Access Compliance Report Public Rights-of-Way (Curb Ramps)

Intersection ID: 52081Main Street: LAWYERS_RDCross Street: E_W_T_HARRIS_BVLocation:SWADA ID: 4918CF887A6FRamp Type: ParaInitial Pass/Fail: FailOverall Compliance: NoSeverity Score: 13.75

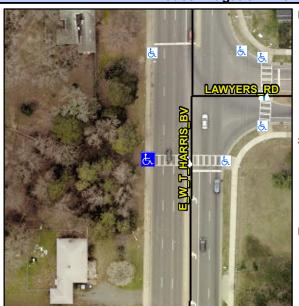
Compliance Description		Data	Compliance Description		Data
N/A	Ramp Length LT (in)	69.0	N/A	Ramp Length RT (in)	59.0
Yes	Ramp Width LT (in)	72.5	Yes	Ramp Width RT (in)	72.5
No	Ramp Slope LT (%)	8.6	Yes	Ramp Slope RT (%)	3.1
No	Ramp XSlope LT (%)	2.8	Yes	Ramp XSlope RT (%)	1.2
N/A	Landing Length (in)	N/A	N/A	DWS Provided?	N/A
N/A	Landing Width (in)	N/A	N/A	DWS Contrast?	N/A
N/A	Landing Slope (%)	N/A	N/A	DWS Length (in)	N/A
N/A	Landing X Slope (%)	N/A	N/A	DWS Full Width?	N/A
N/A	Landing Curb? (Y/N)	N/A	N/A	DWS Offset (in)	N/A
N/A	Shared Landing?	N/A			
N/A	Gutter Ponding?	N/A	N/A	Gutter Slope (%)	N/A
N/A	Gutter Lip Ht (in)	N/A	N/A	Gutter X Slope (%)	N/A
N/A	Painted X Walk1?	Yes	N/A	Painted X Walk2?	N/A
	X Walk 1 Direction	To E		X Walk 2 Direction	N/A
N/A	X Walk 1 Width (in)	120.0	N/A	X Walk 2 Width (in)	N/A
	X Walk 1 Slope (%)	1.6		X Walk 2 Slope (%)	N/A
	X Walk 1 X Slope (%)	1.8		X Walk 2 X Slope (%)	N/A
N/A	Ramp inside XWalk1?	Yes	N/A	Ramp inside XWalk2?	N/A

Remove & Replace Entire Ramp.
